BID PACKAGE 02 – ADDENDUM 01**Date:** January 10, 2020**Re:** Wilma P Mankiller Health Center Expansion**From:** James R Childers Architect, Inc.
45 South 4th Street
Fort Smith, Arkansas 72901

CHANGE NARRATIVE LETTER

TO: MATHEW THOMAS- CHILDERS ARCHITECTS
FROM: STEPHEN EDMONDSON, TREY SMITH, BETSY WELLS– HP ENGINEERING, INC.
DATE: 1/10/2020
PROJECT: WPMHC EXPANSION BID PACKAGE 02 ADDENDUM 01

SHEET NUMBER:
E1.04
POWER PLAN LEVEL 02 SECTOR 01

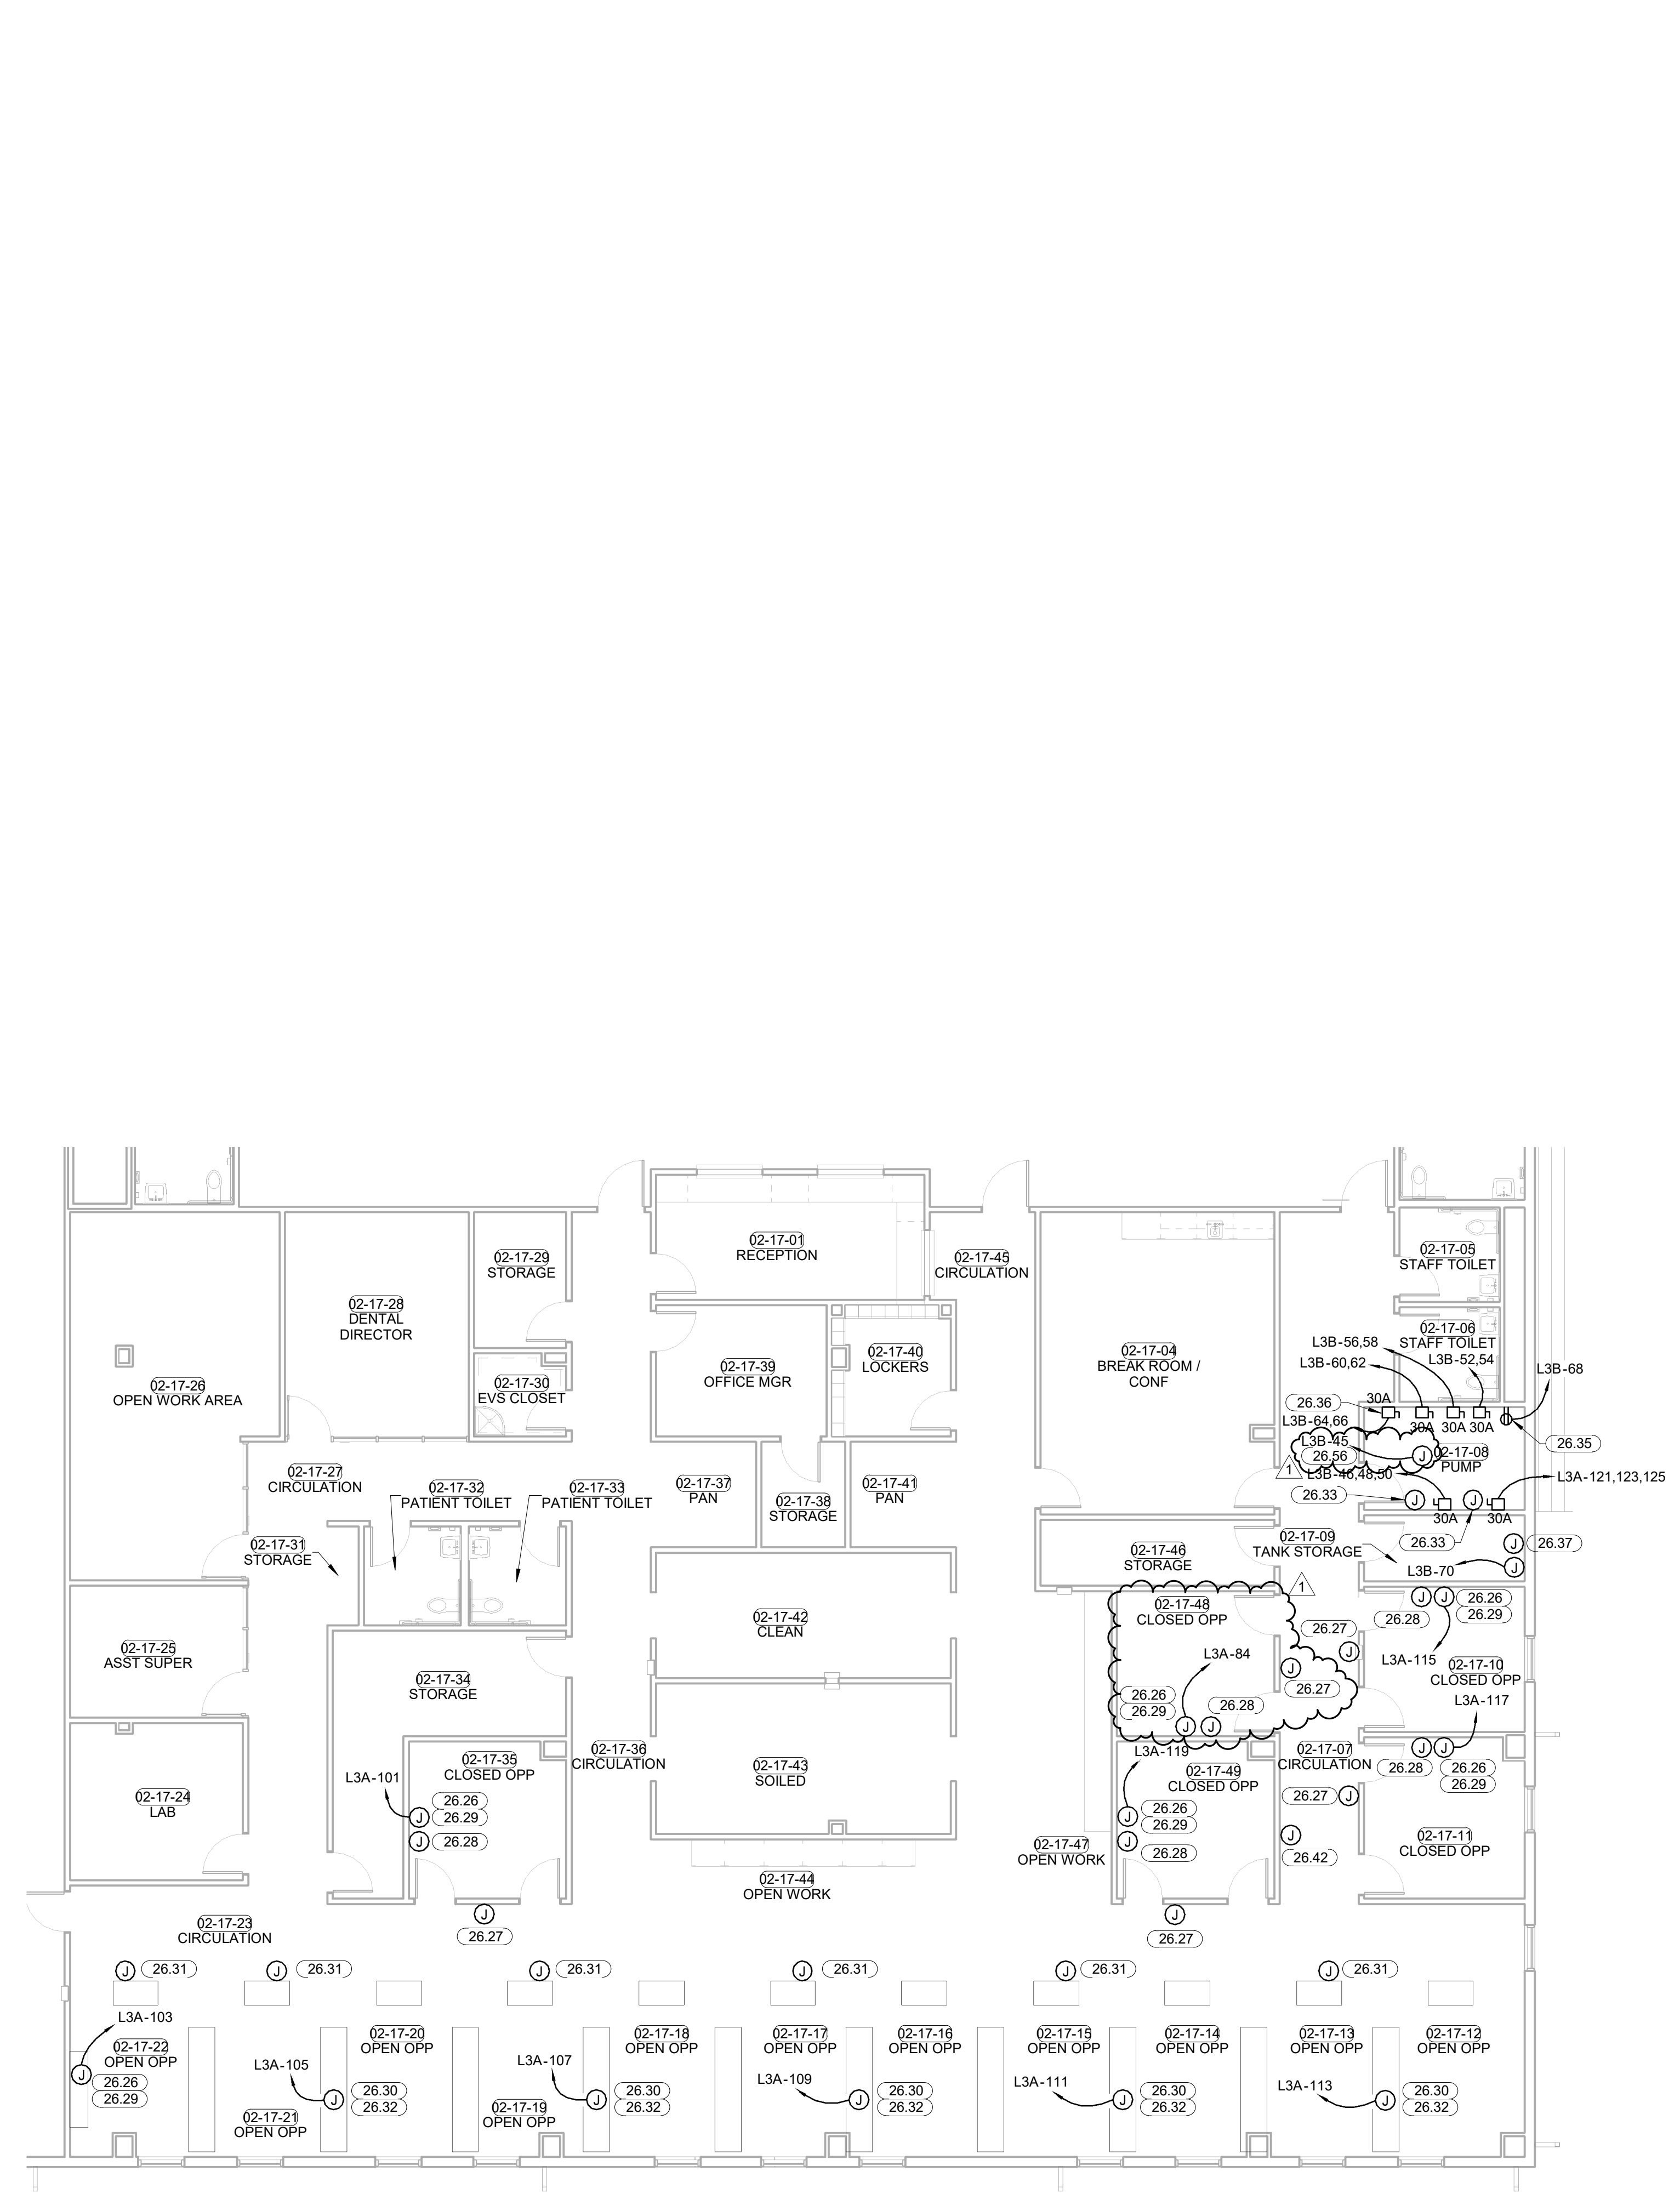
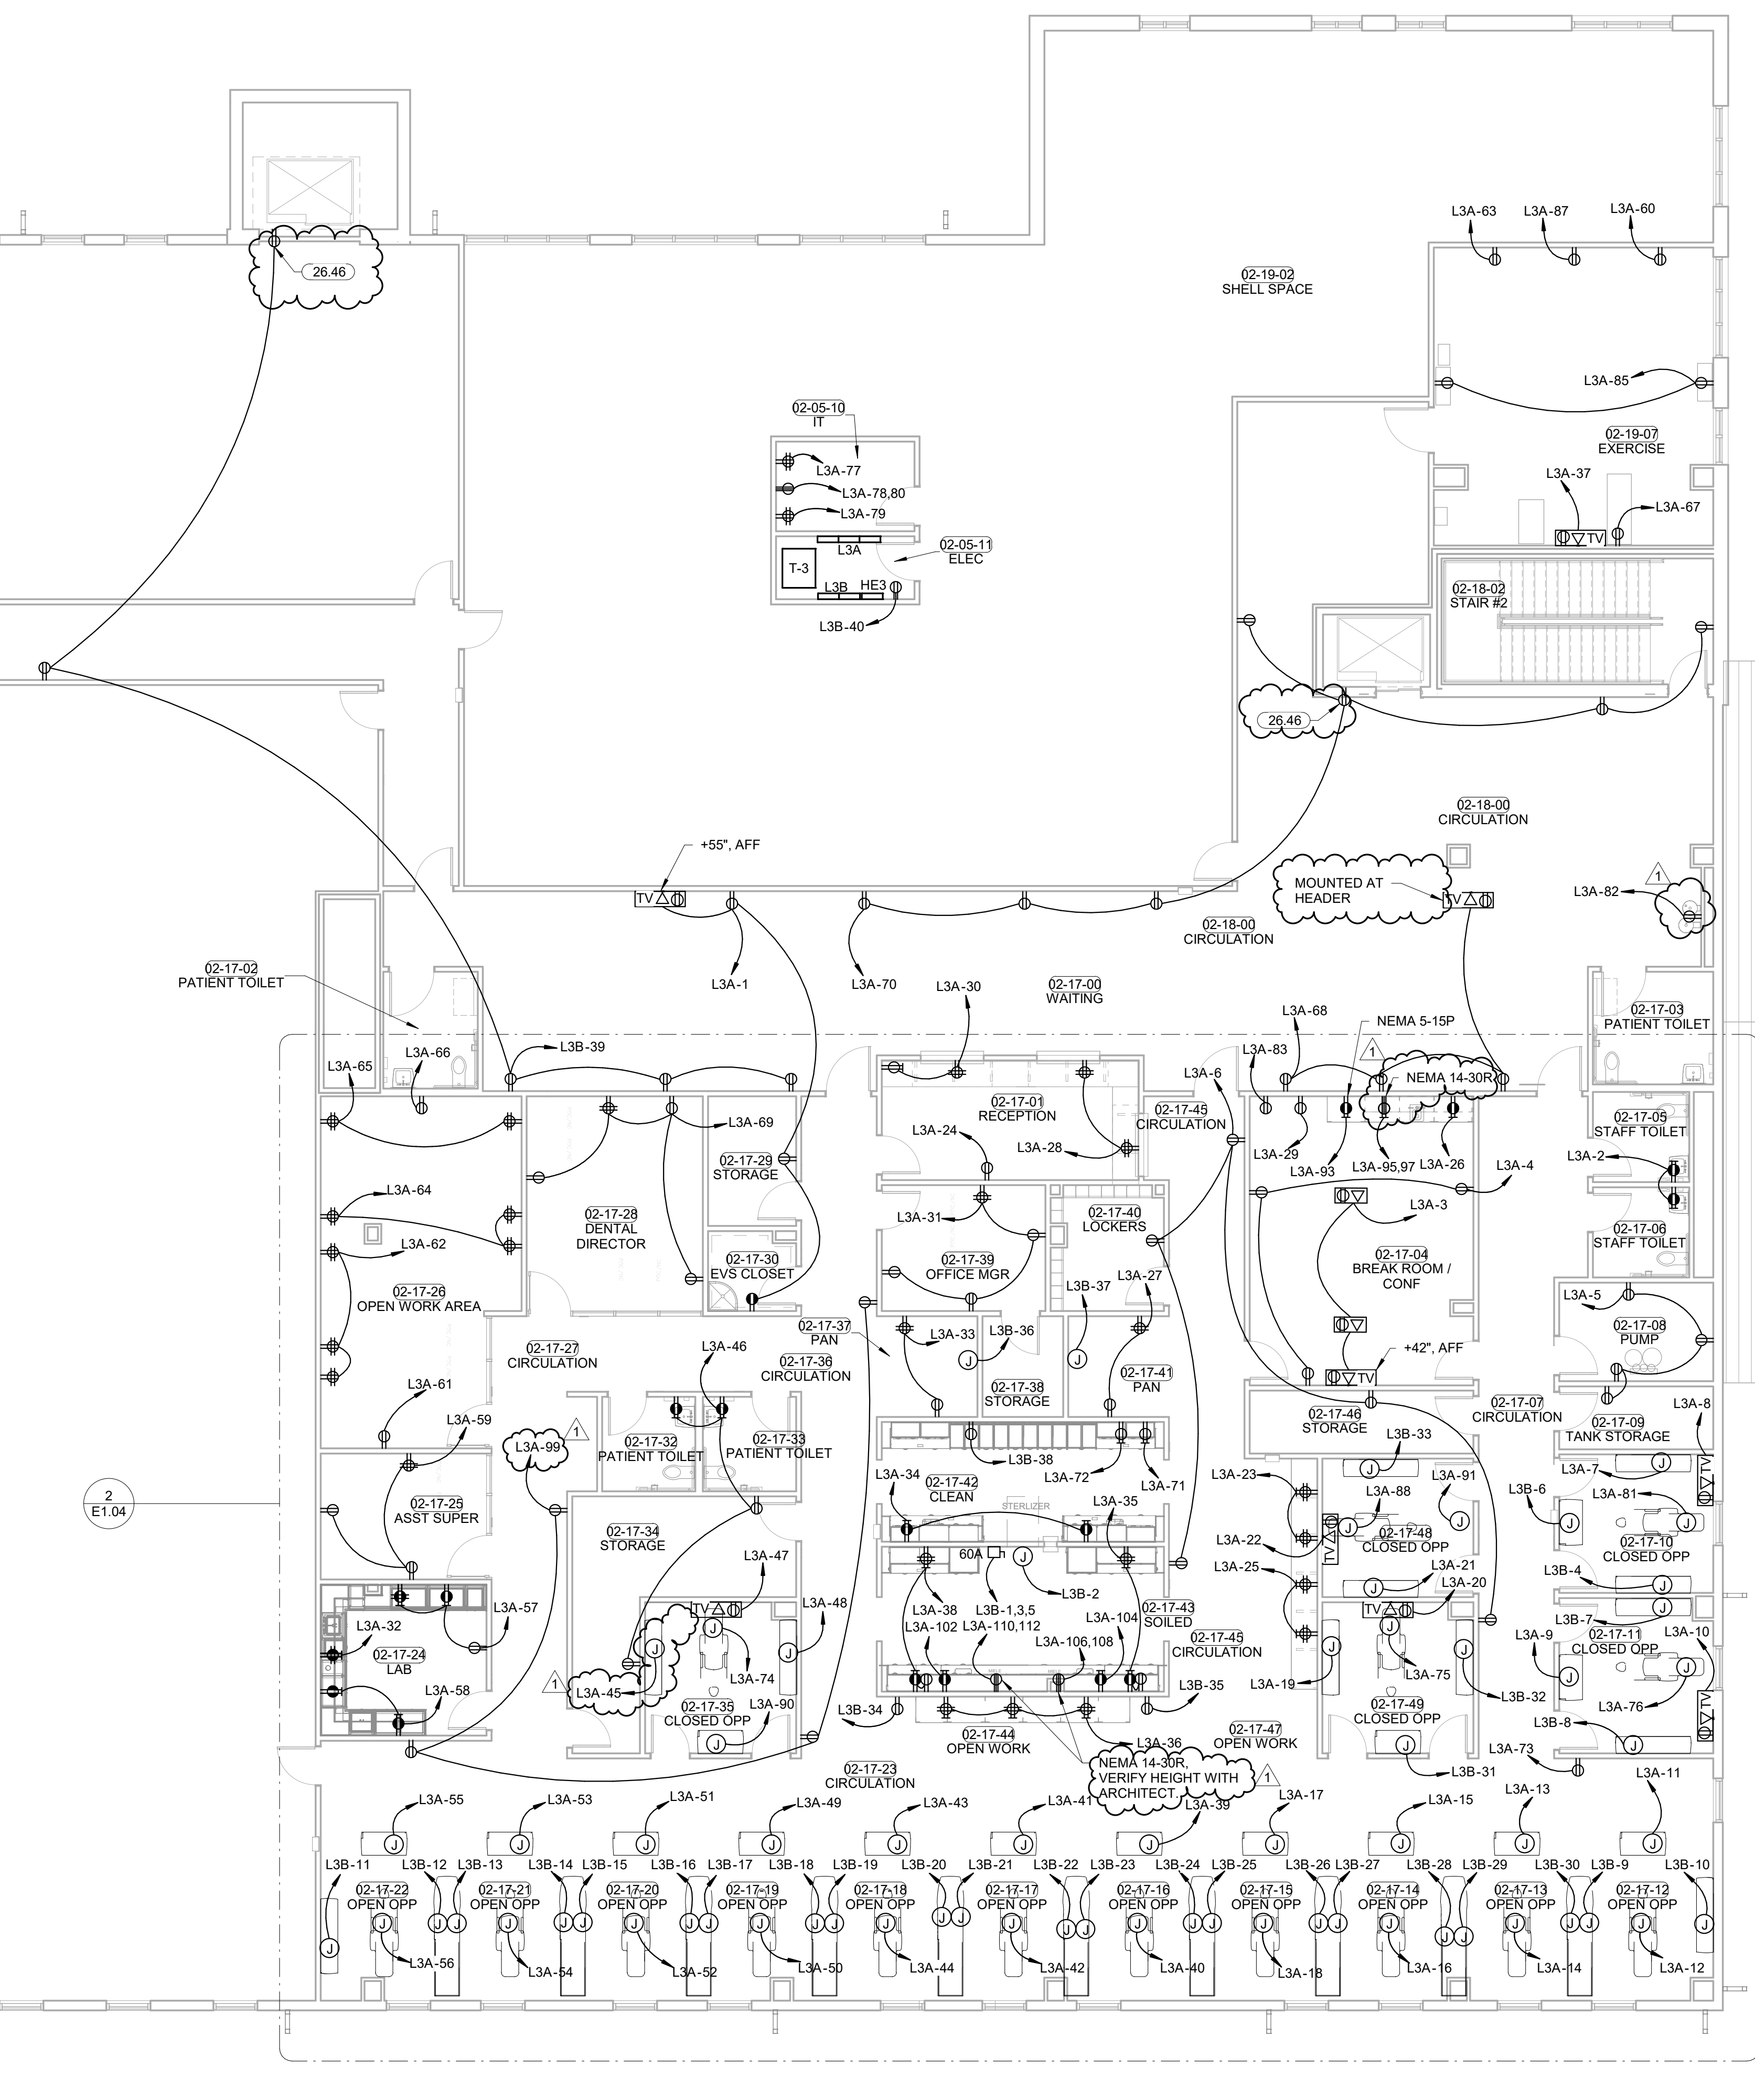
1. E1.01
 - a. Notes updated
2. E1.03
 - a. H1 panel relocated.
3. E1.04
 - a. Detail 1 – Revised water fountain receptacle to not be GFI.
 - b. Detail 1 – Added (1) circuit in Closed Opp 02-17-35 for receptacles.
 - c. Detail 1 – Revised circuit number for Circulation 02-17-27 receptacles.
 - d. Detail 1 – Revised note for miele instrument washer receptacles in Soiled 02-17-43 to include NEMA type.

- e. Detail 1 – Added NEMA rating for coffee receptacle in Breakroom/Conf 02-17-04.
 - f. Detail 2 – Revised orientation of detail.
 - g. Detail 2 – Added (1) junction box for x-ray in Closed Opp 02-17-48.

- h. Detail 2 – Added (1) junction for remoted station in Closed Opp 02-17-48.
 - i. Detail 2 – Added (1) junction for exposure button in Circulation 02-17-07.

- j. Keynotes – Removed keynote 26.39.
4. E1.05
- a. Detail 1 – Added keynote 26.46 to elevator service GFCI receptacle.
 - b. Keynotes – Added to sheet.

SHEET NUMBER:
E1.13
MAINTENANCE/
MECH YARD
POWER/LIGHTING

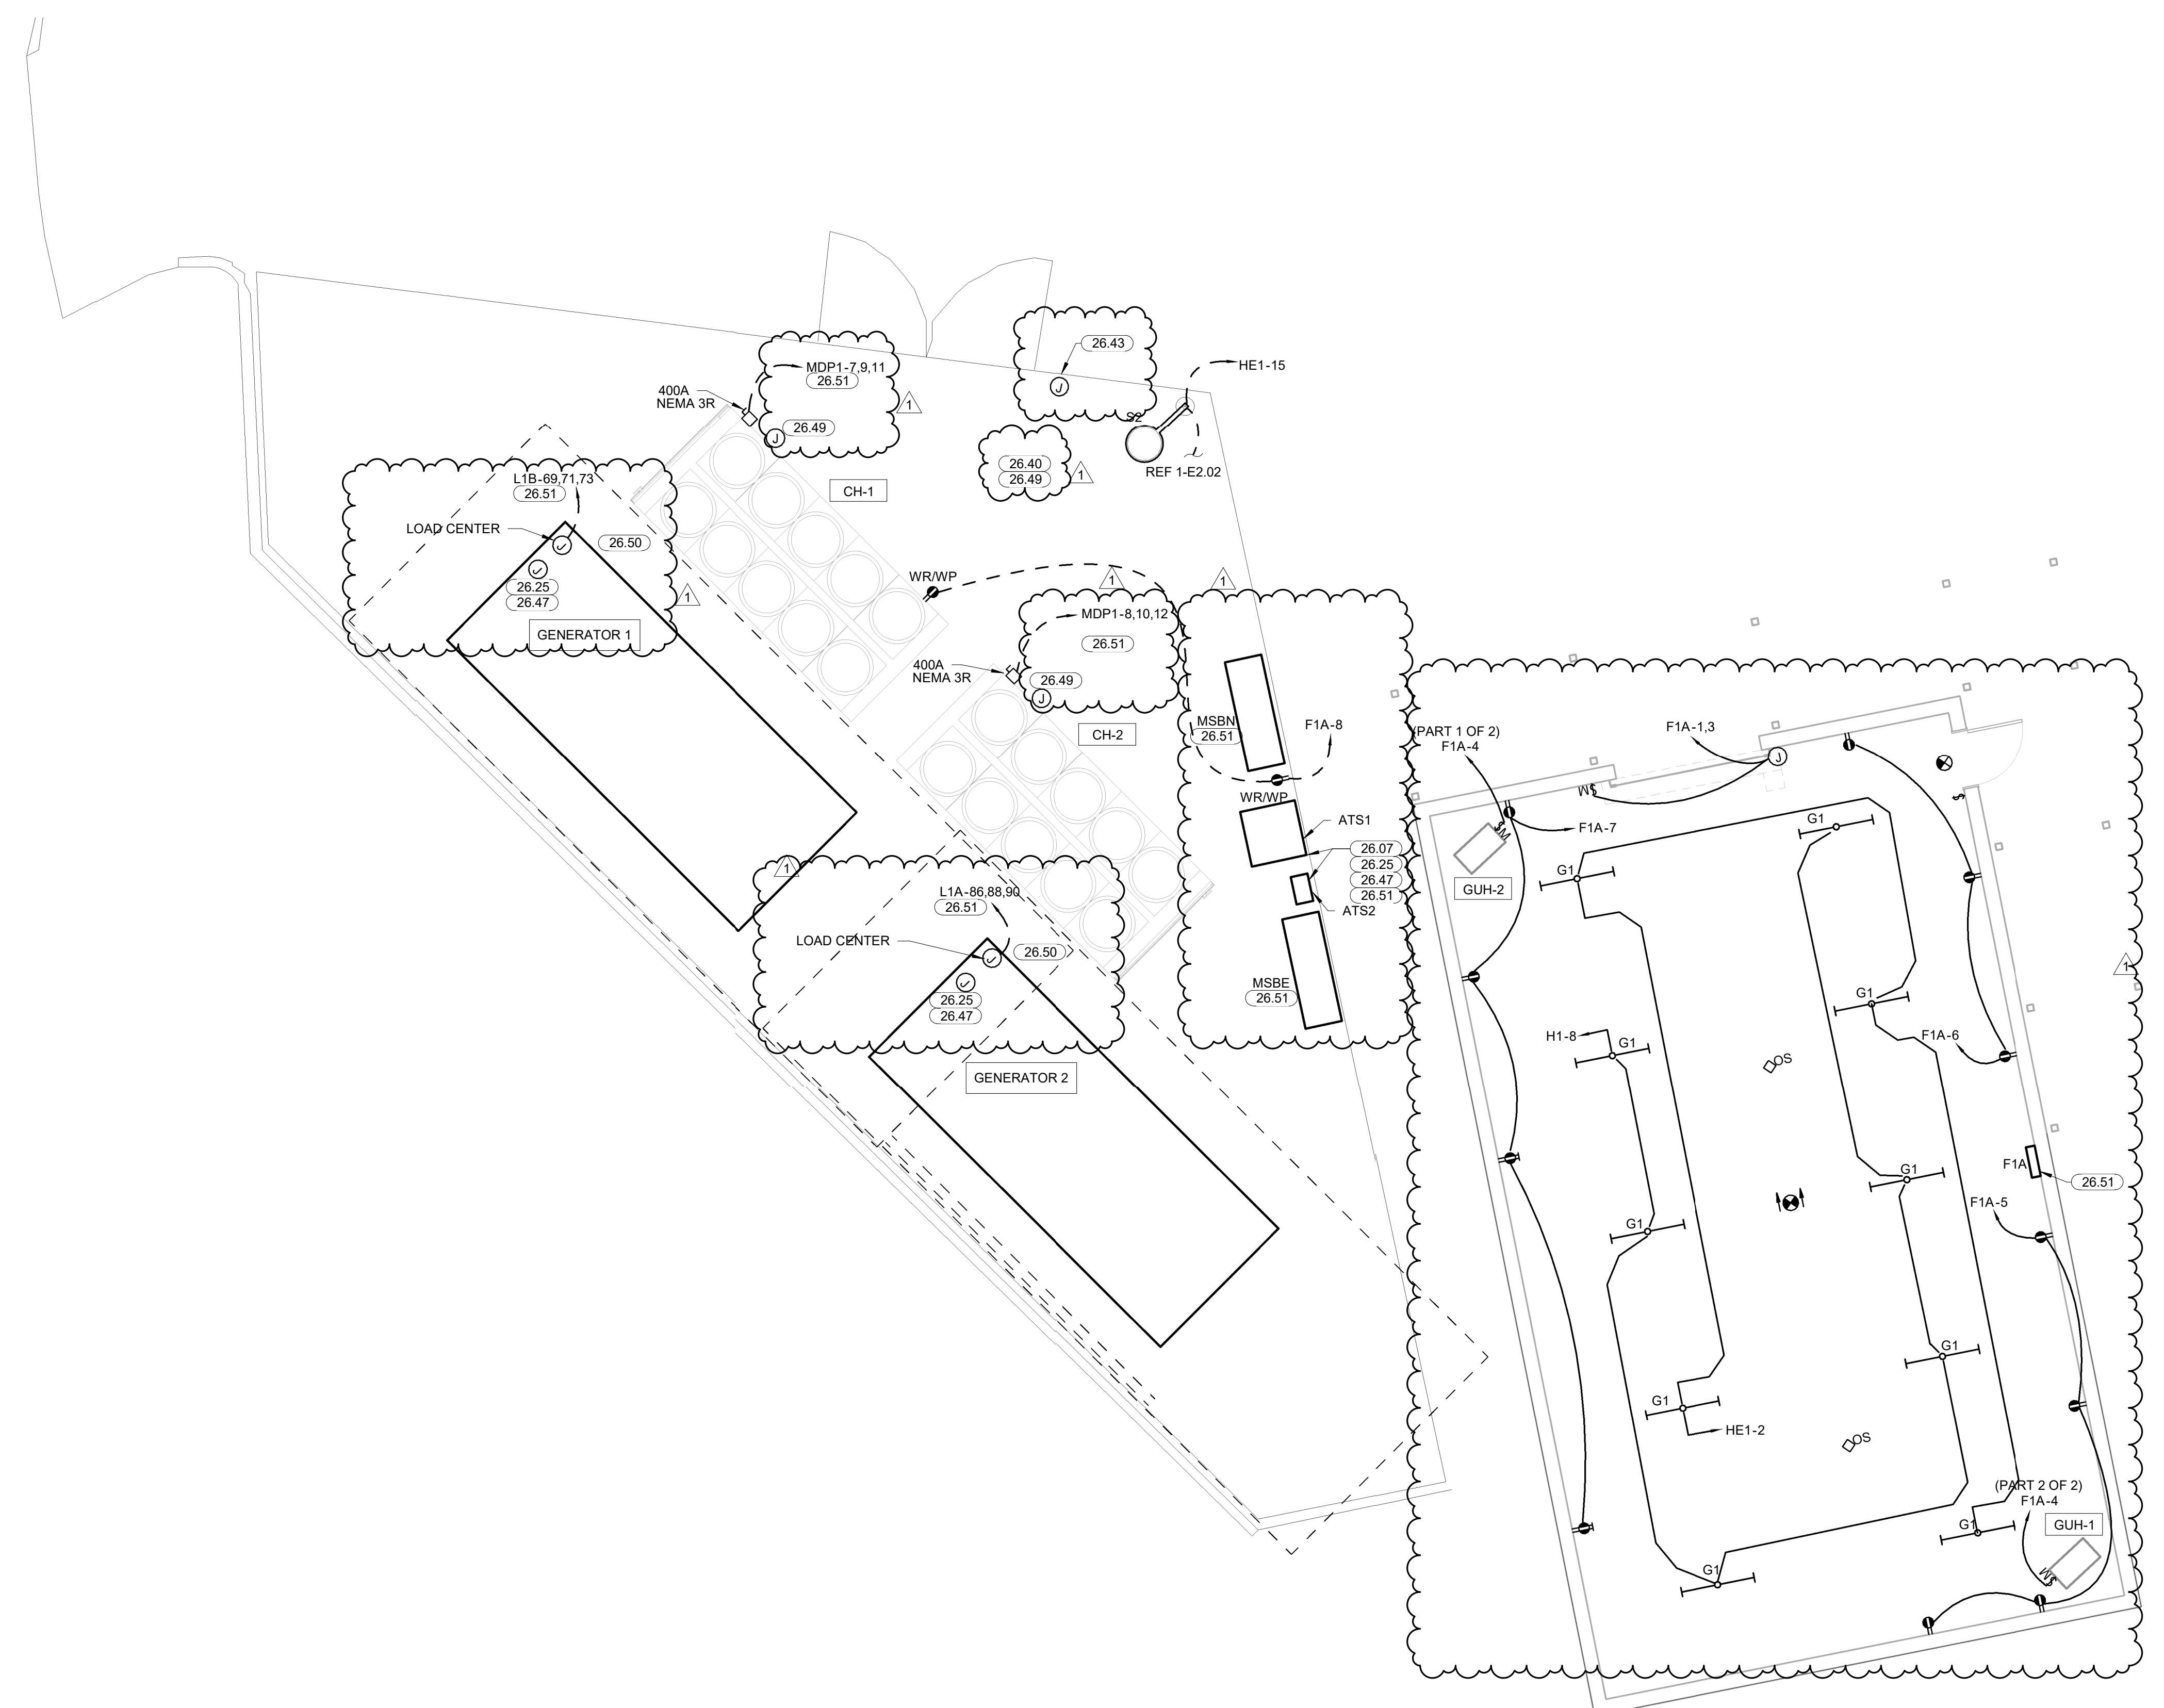
9. E1.10
- a. Circuits have been updated.
10. E1.11
- a. Circuits have been updated.
11. E1.13
- a. Key notes have been revised
 - b. Circuits have been updated.

- c. Detail 1 – Added EF-9 location and equipment tag.
12. E1.14
